NOTICE OF PROPOSED DEVELOPMENT

APPLICATION NO: DA 2025 / 00163 1

PROPOSED SINGLE STOREY DWELLING

45 FEDERATION DRIVE, SORELL, TAS - 7172

Sheet: ELEVATIONS			
Drawn: GK			
Scale: 1 : 100	Size: A3	Date: 17/06/2025	
Project: 45FDS/TAS/ARCH-2025		Sheet No.: A06	Rev: 1

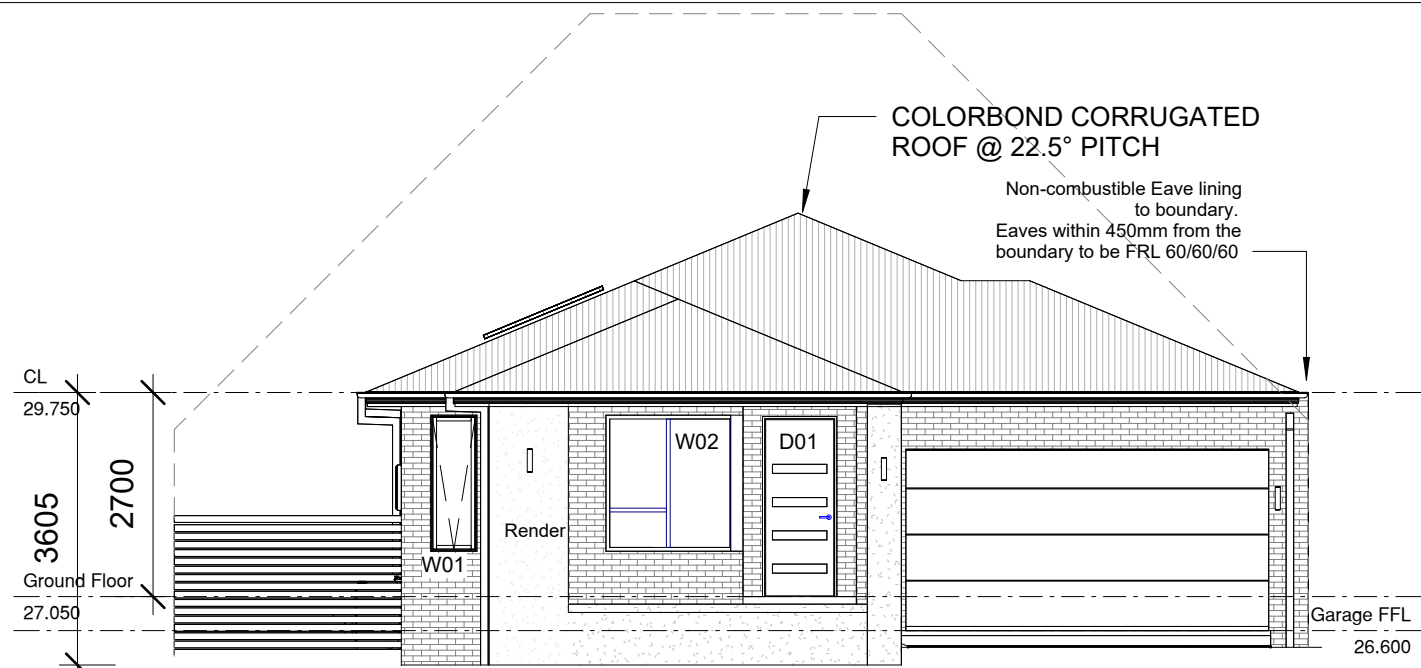
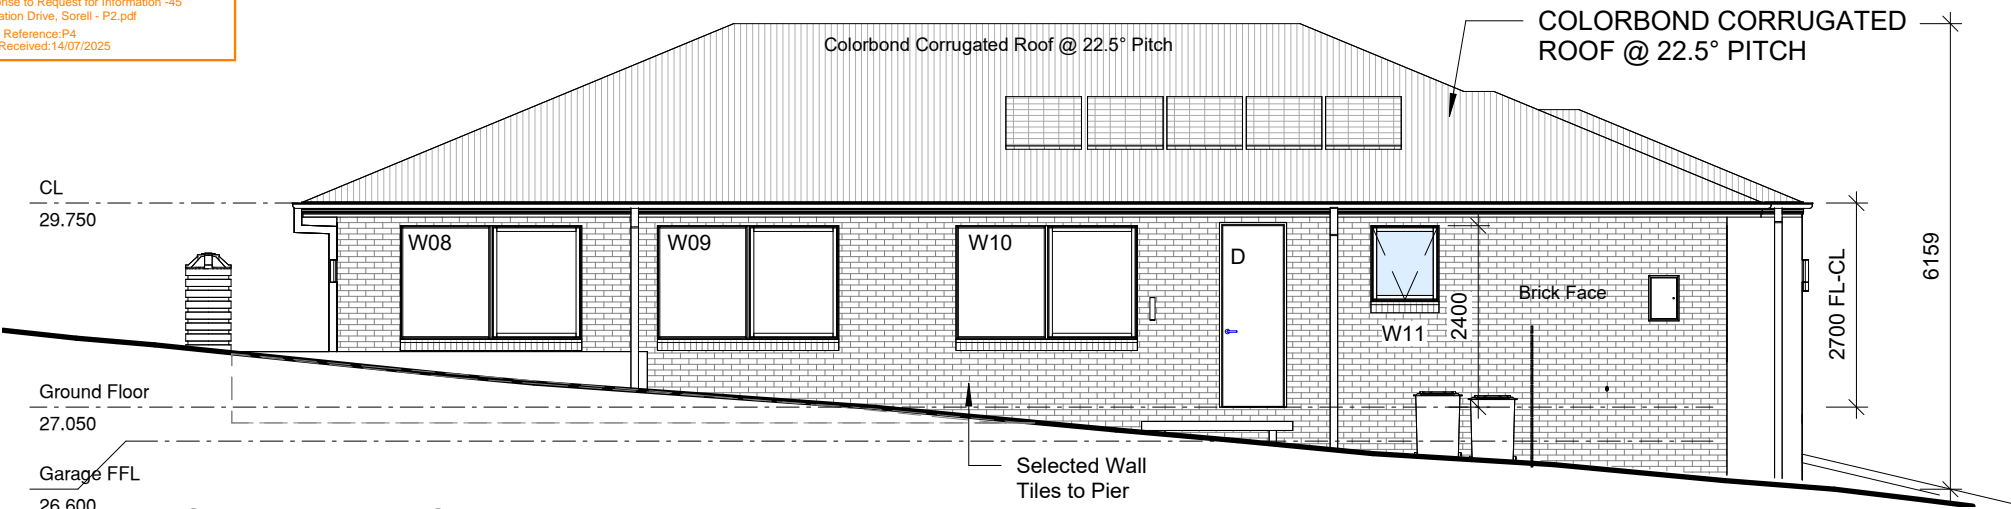
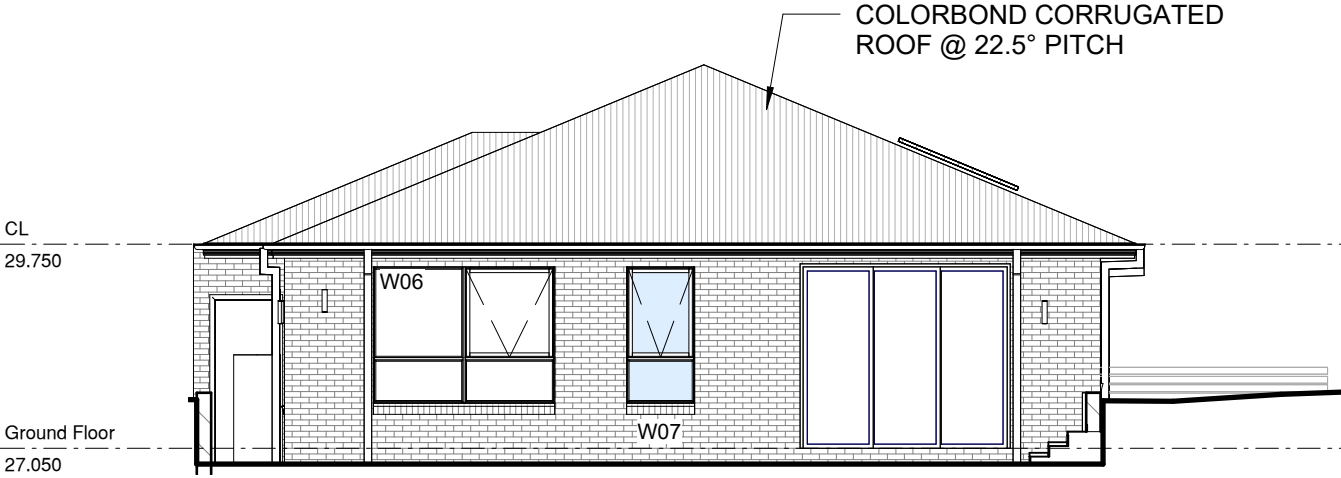
Item	Comments	Response
Administration	Please provide a written submission, prepared by a suitably qualified and experienced planner, building designer, architect or similar setting out how the proposal is said to satisfy clause 8.4.2 P2 in terms of proximity to the boundary, future overshadowing impacts and compatibility with the surrounding area.	Proposal satisfy Tasmanian Planning Scheme 8.4.2 A2 Setbacks and Building Envelope <ul style="list-style-type: none">Garage is 5500mm Setback from a primary frontage.Shadow Diagrams Created Refer A15Building Envelope Shown Refer Elevations A06Adjoining Lots are vacant
